ADDENDUM NO. 01
January 13, 2022

To Drawings and Specifications dated December 17, 2021

CLINE ELEMENTARY SCHOOL CAMPUS REPLACEMENT
FOR FRIENDSWOOD I.S.D.

Prepared by: PBK
11 Greenway Plaza, 22nd Floor
Houston, TX 77046-1104
PBK Project No: 20380

S-313

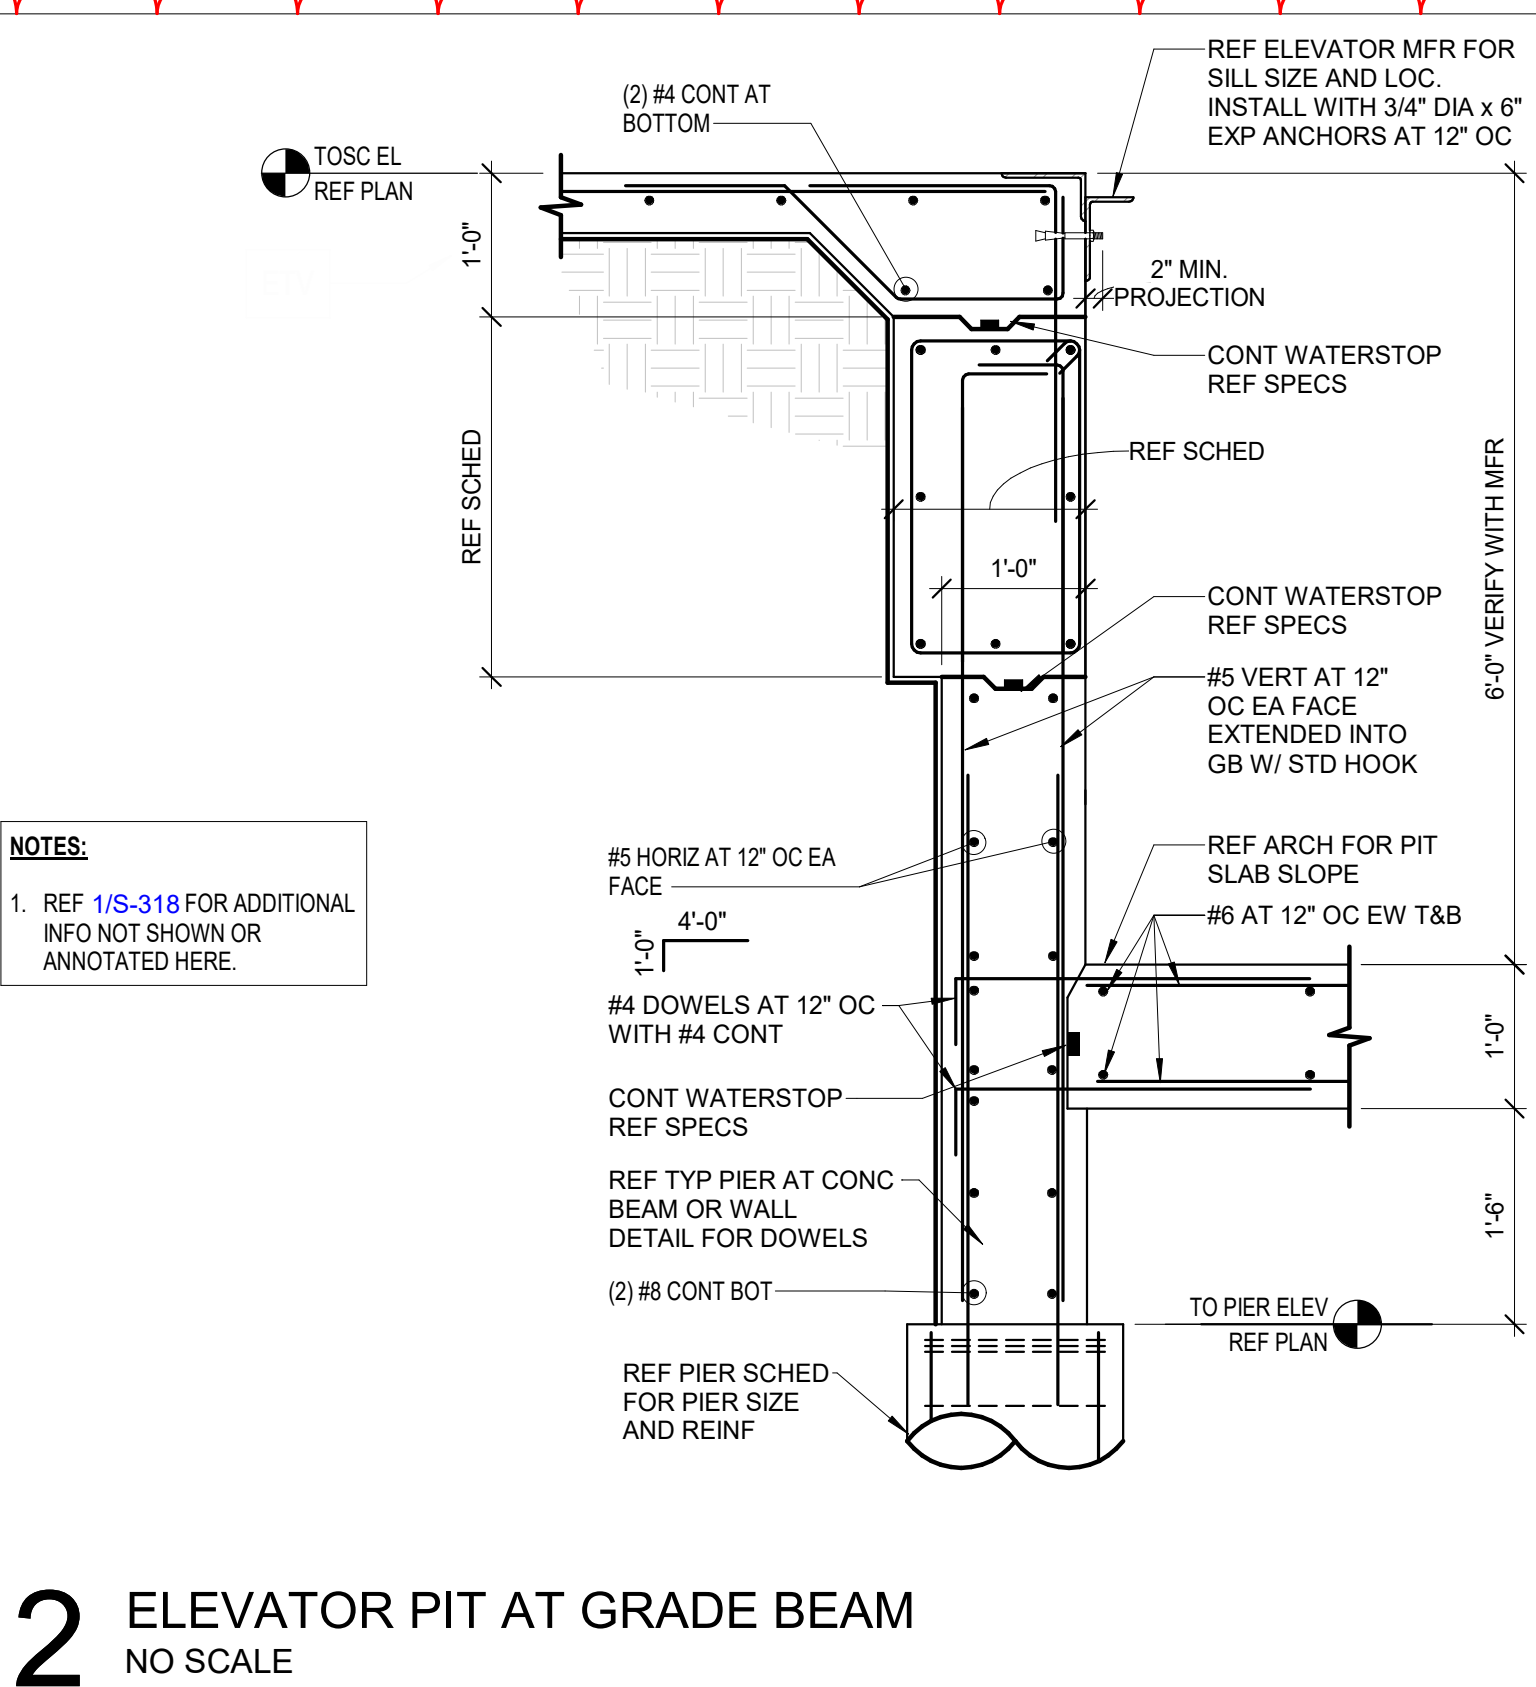
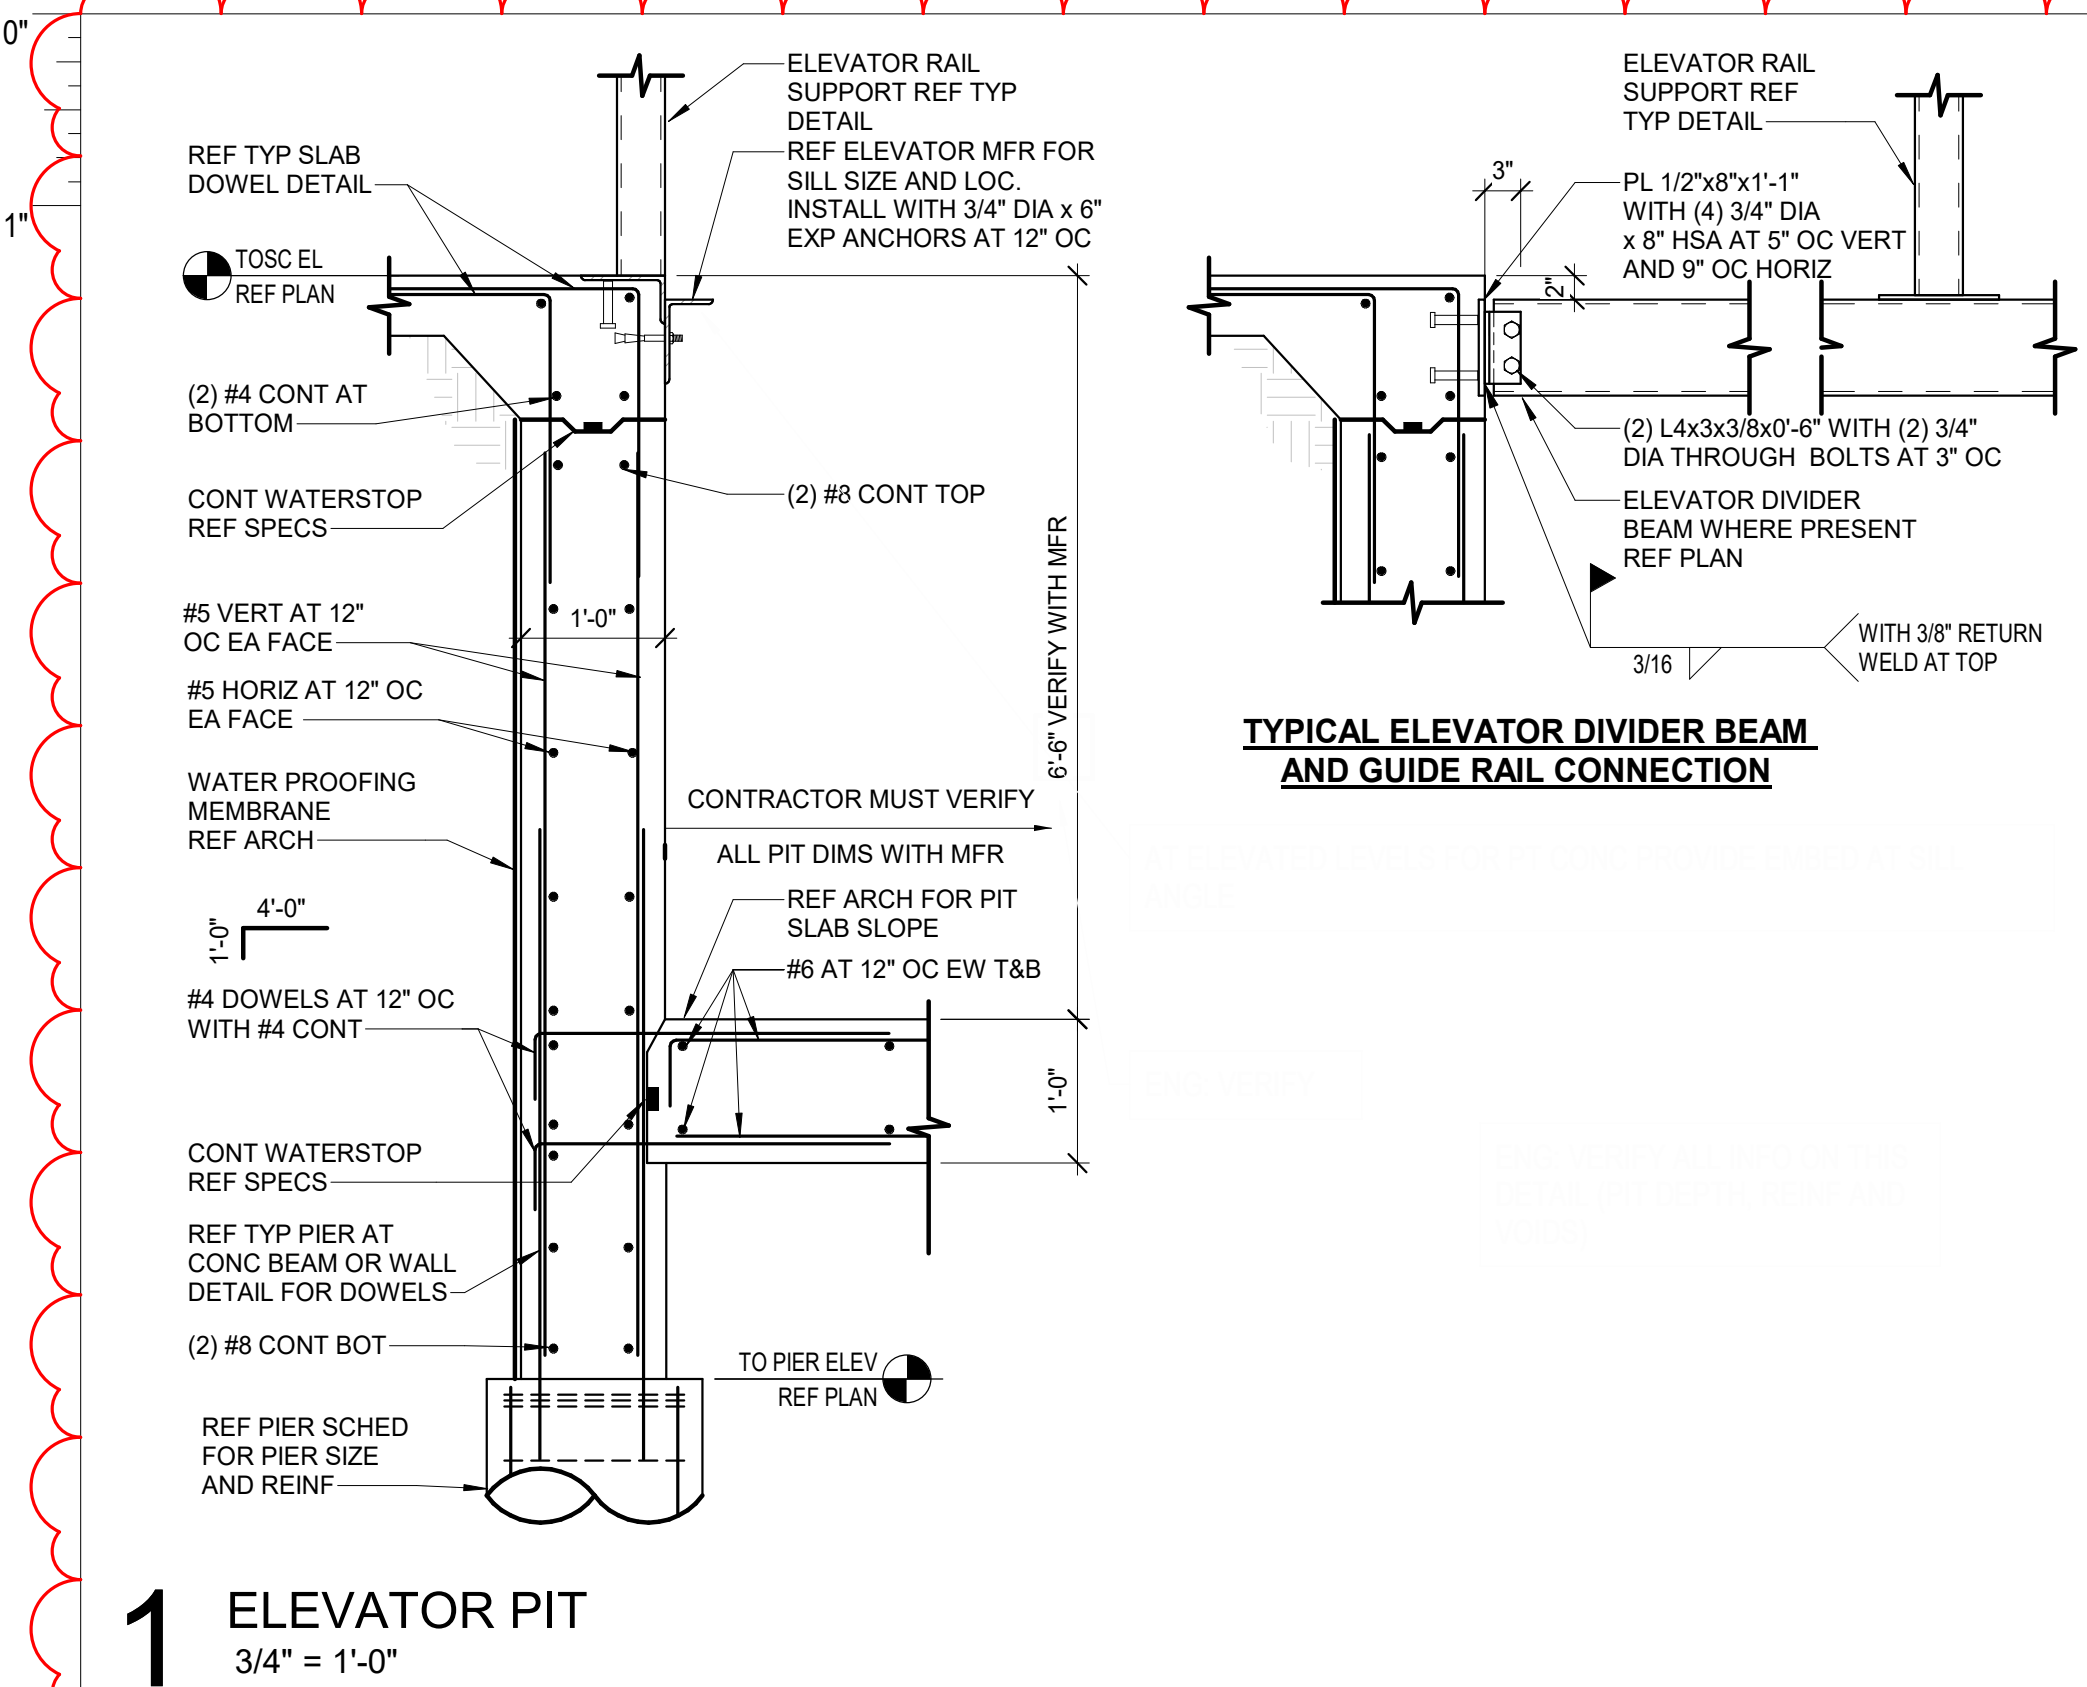
- a. New detail 9 added to sheet. See revised sheet.
- Item No 16 **Sheet S-318 – ELEVATOR PIT DETAILS**
 - a. Replace this sheet in its entirety. See revised sheet.

F-3709

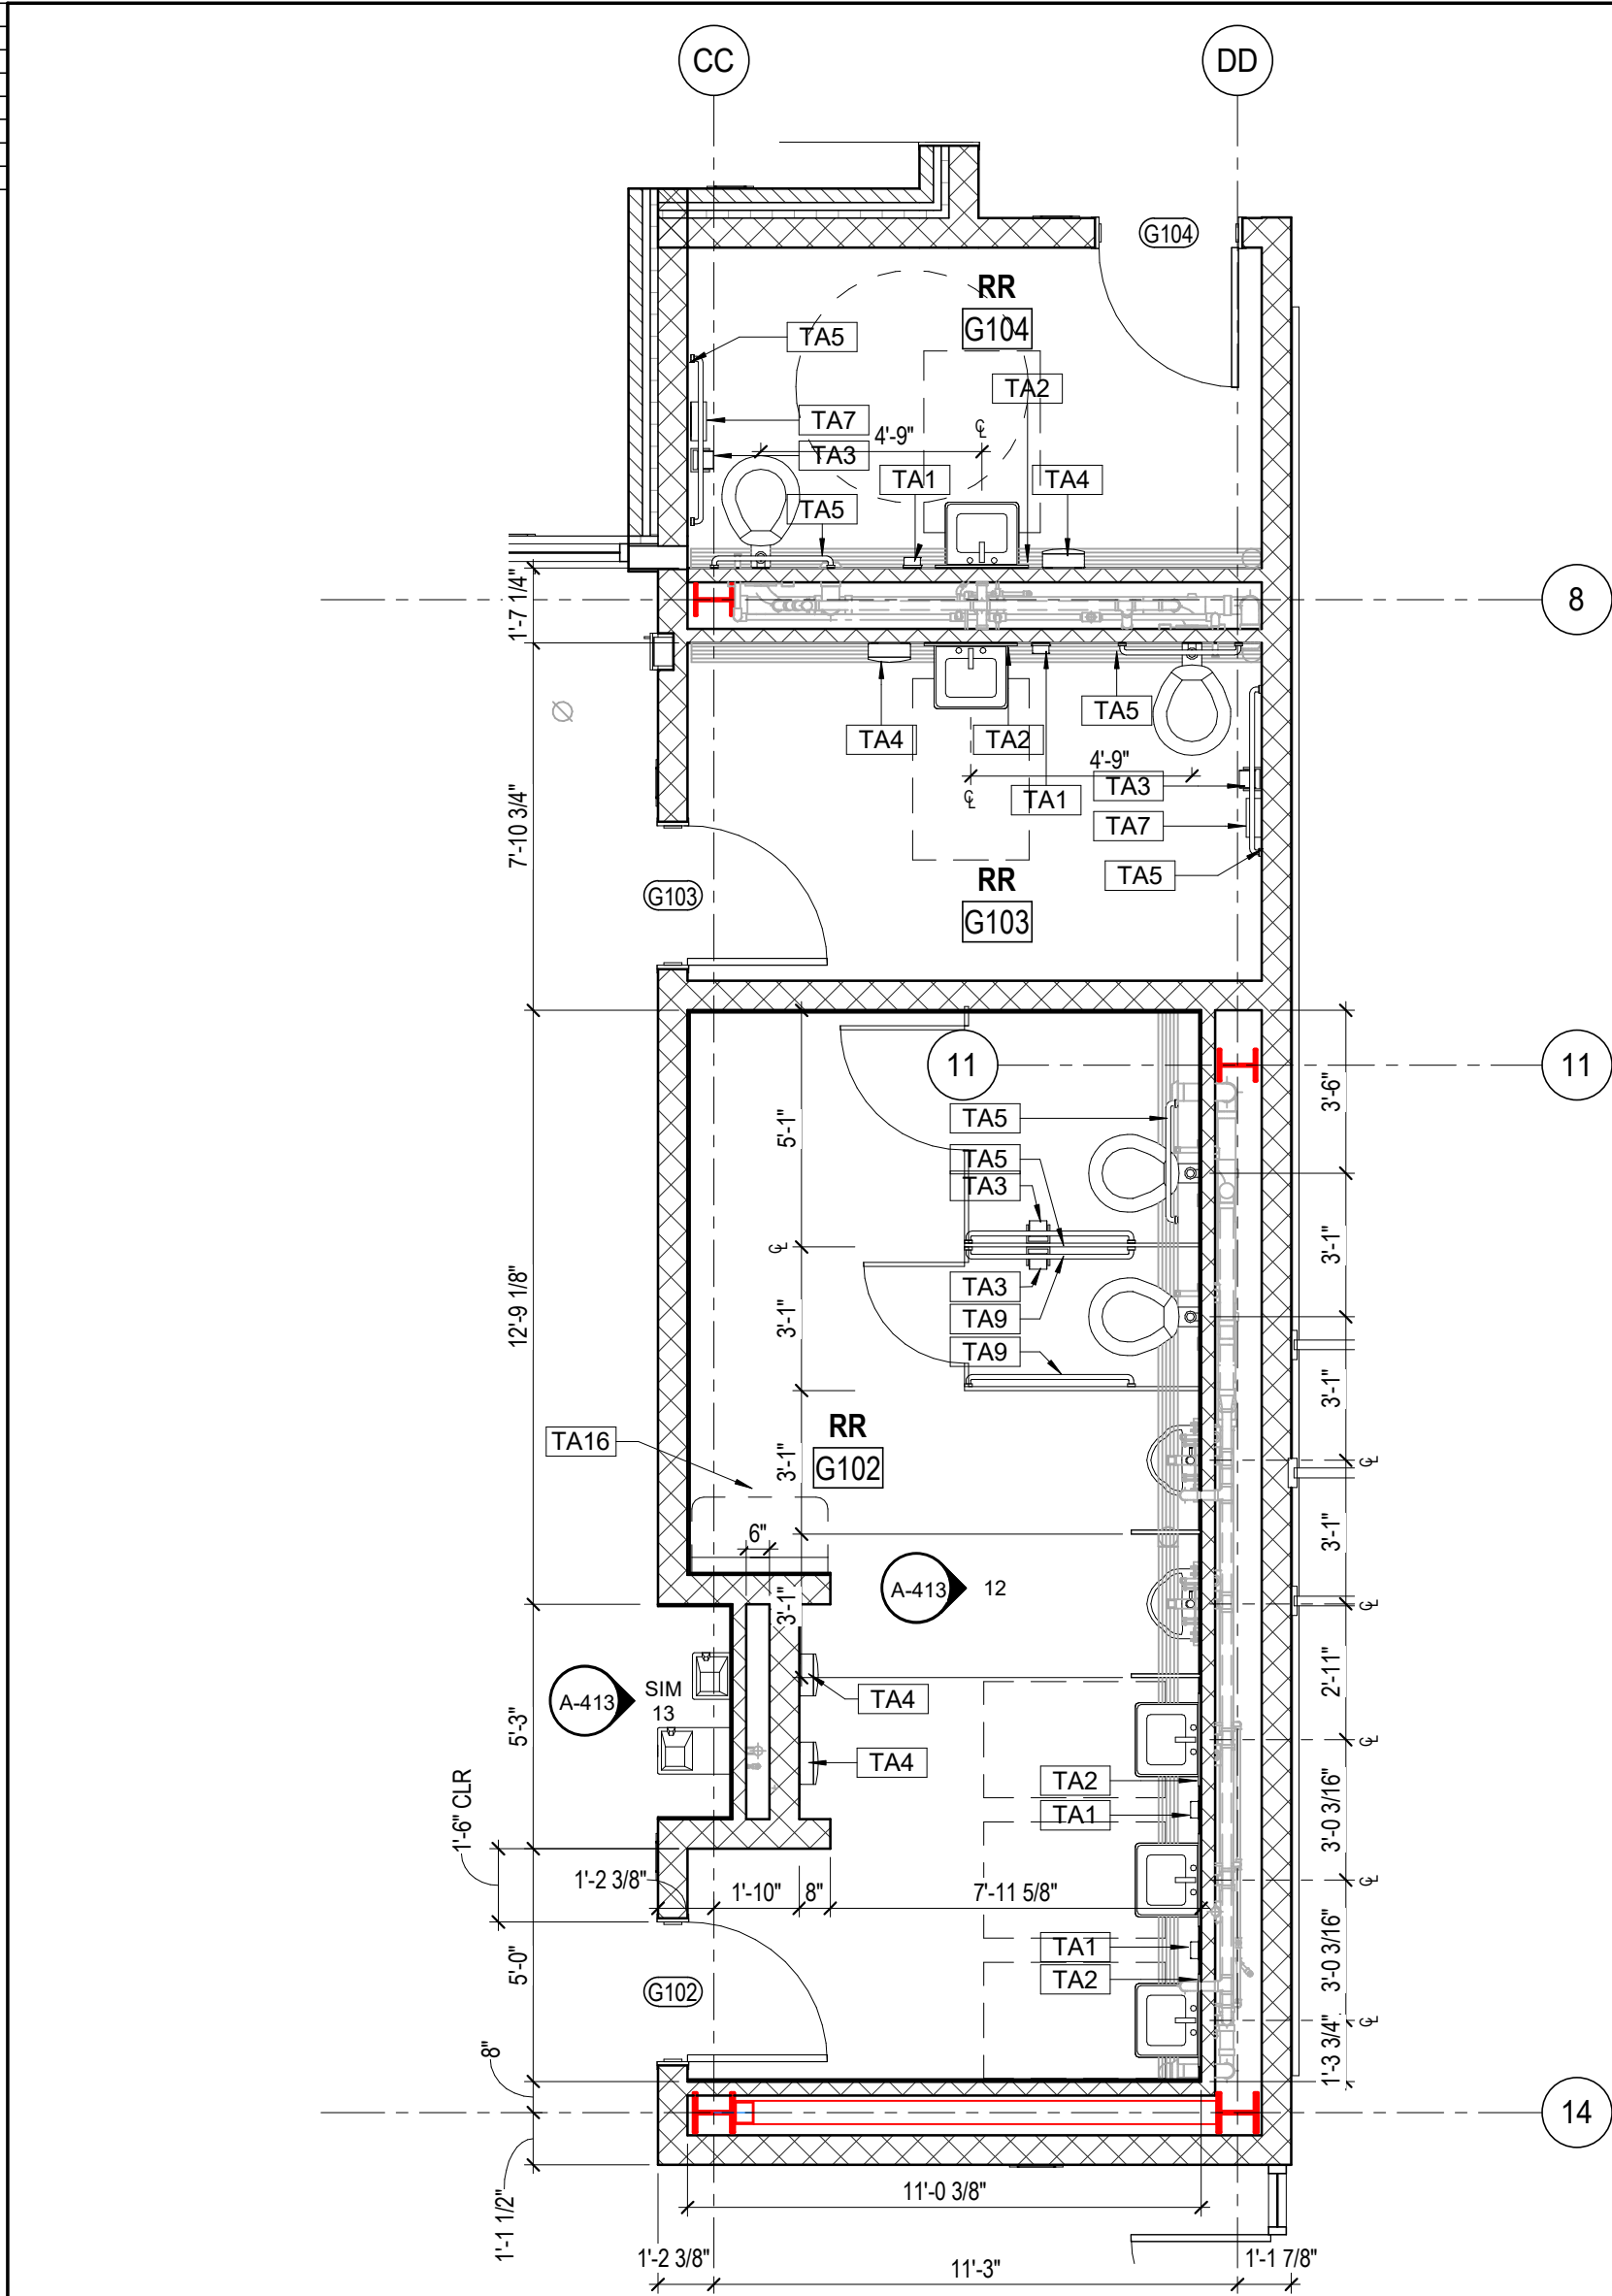
- Item No. 28 What is the extent for MC-1 ceiling type in rooms B101 STR B, B102 Str B, B103 Learning, B104 Str C, and B105 Learning Str? Please clarify and provide RCP for these locations?
Refer to Revised A-202B

- Item No. 25 **Sheet A-202B:** Revised ceiling material hatch on ceiling plan.
- Item No. 26 **Sheet A-412:**
 - a. Revised partition type at Storage D2-3.
